# Technical Bulletin

TSB No. TS 05 07167

**SUBJECT: SAFETY RECALL CAMPAIGN "MU" REPLACEMENT OF M/T GEARSHIFT CABLE CLIP**

**MODEL(S): AERIO(RH420 AND RH423) MANUAL TRANSMISSION ONLY**

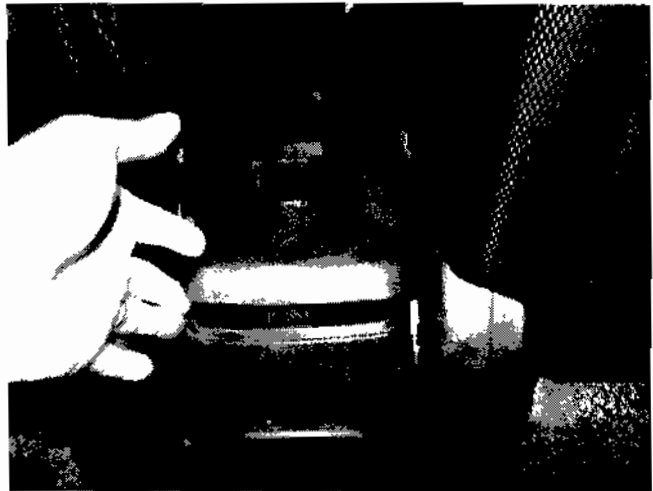
Part Numbers	Description	QTY	Notes
09385-08004	Clip	1	See picture

**Gearshift lever clip replacement**

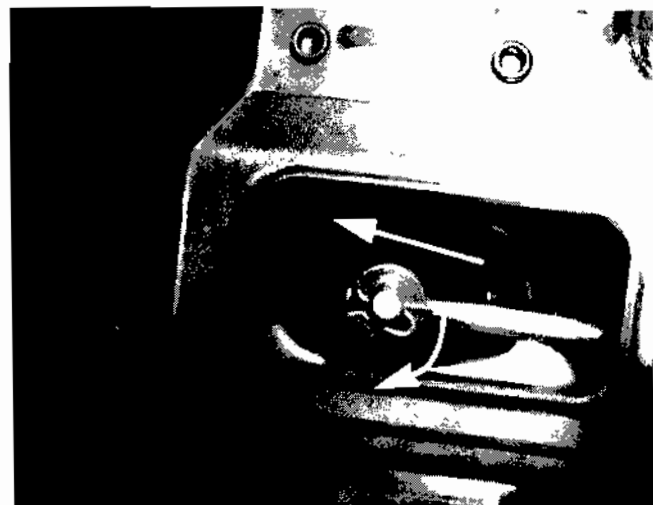
- Locate the gearshift clip from the right front passenger side of the shifter housing.

- Bend the hooked end of the clip down to remove the old clip from the shifter link.
- Install the new clip in the same position.
- Re-assemble the console by reversing these instructions.
